FMSM
ENGINEERS

August 14, 1997

Re: Sinkhole Review
Lots 21, 22, 23 and 28
Blankenbaker Commerce Centre
Jefferson County, Kentucky

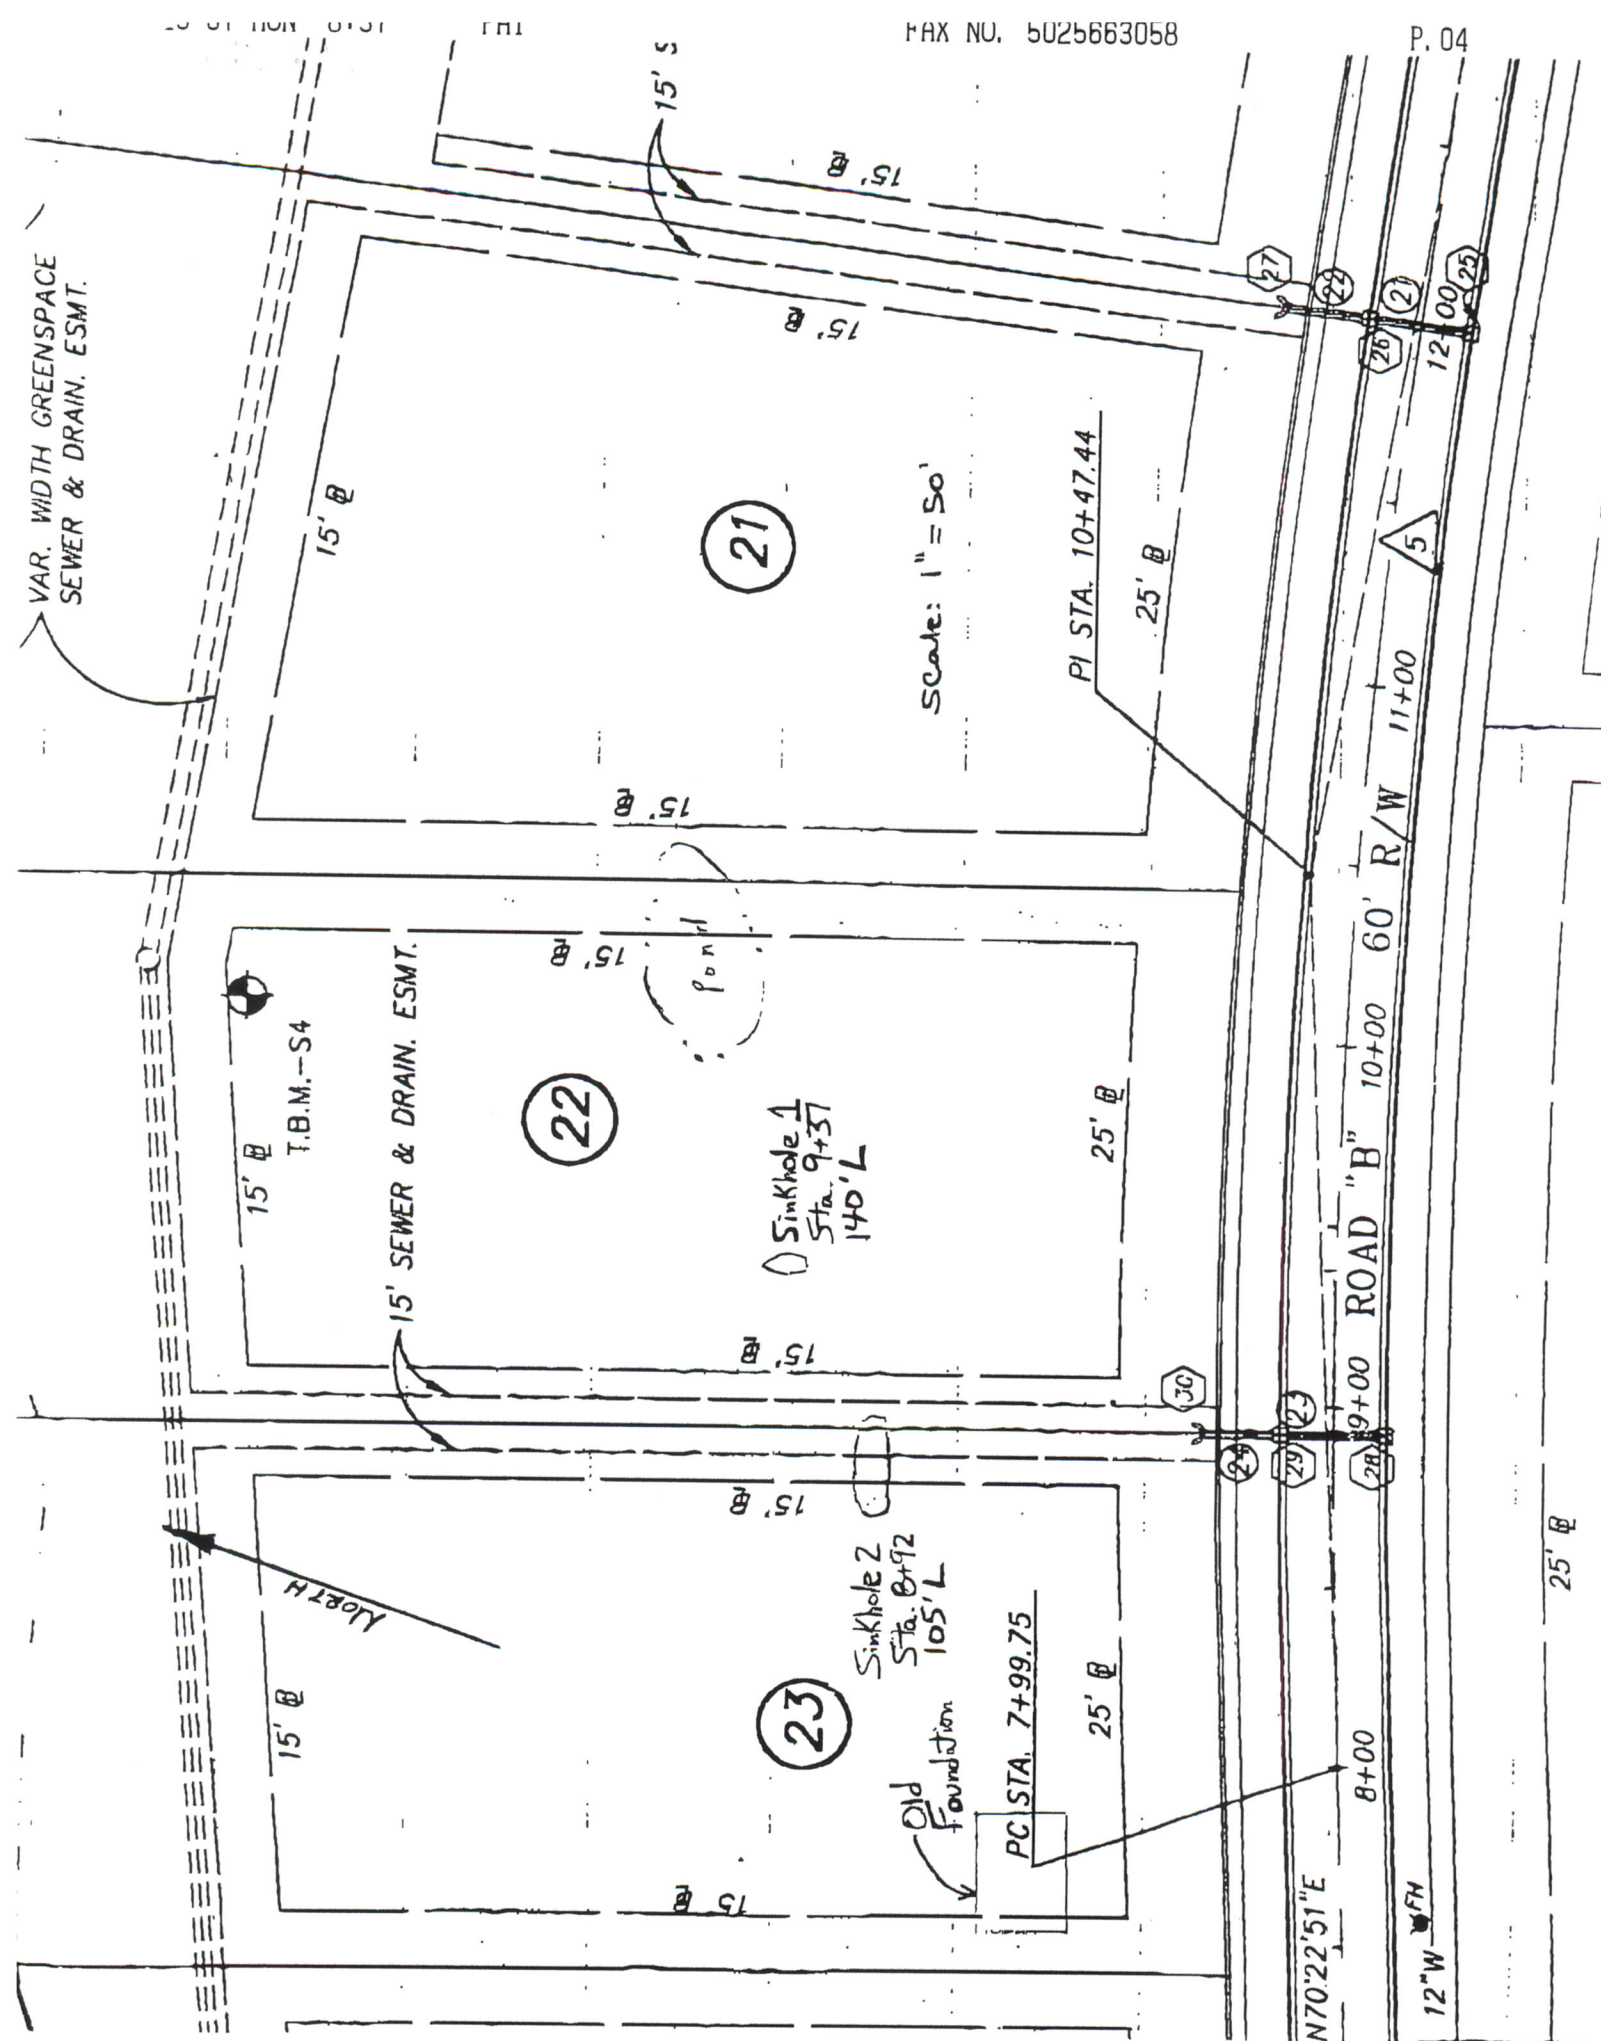
An approximate 10-foot by 10-foot by 4-foot deep excavation had been made to the rock surface. This sinkhole is labeled as Sinkhole 1 on the attached portion of the plan view drawing. It is located at the south-central area of the lot. A one to two-foot wide crevice was observed in the rock surface running in a north-south direction. On the north side of the excavation, the crevice had been cleaned to a depth of about three feet and was clay-filled below this depth. The crevice had not been cleaned on the south side of the excavation. Prior to any treatment, the excavation will need to be extended to the south to determine the limits of the crevice.

A pond was also observed on the east side of the lot and is marked on the attached layout.

An approximate 10-foot by 20-foot by 5-foot deep excavation had been made to the rock surface. This sinkhole is labeled as Sinkhole 2 on the attached portion of the plan view. It is located at the extreme east side of the lot. The eastern half of this sinkhole is located in a 15-foot wide sewer and drainage easement, and it appears to extend just into Lot 22. An approximate six-inch wide crevice is present in the sinkhole running in an east-west direction. This crevice was probed and an open throat extended to a depth of five feet below the rock surface in several locations. This excavation will need to be extended to the east and west to define the limits of the crevice prior to treatment.

An approximate 25-foot diameter sinkhole (Sinkhole 3) about 2 to 3 feet deep was observed 80 to 90 feet east of the southwest corner of the lot. A tree is present in this sinkhole. No excavation had been performed and an open throat was not visible.

From a geotechnical standpoint, sewers, pavements and buildings should be sited to avoid sinkholes because of an increased risk for damage caused by any future ground collapses. However, this will probably not be possible because Sinkhole 1 is in the central portion of Lot 22²² where pavement or a building will likely be placed, and Sinkholes 2 and 3 are in sewer and drainage easements. Therefore, these sinkholes will need to be treated to help prevent future collapse.
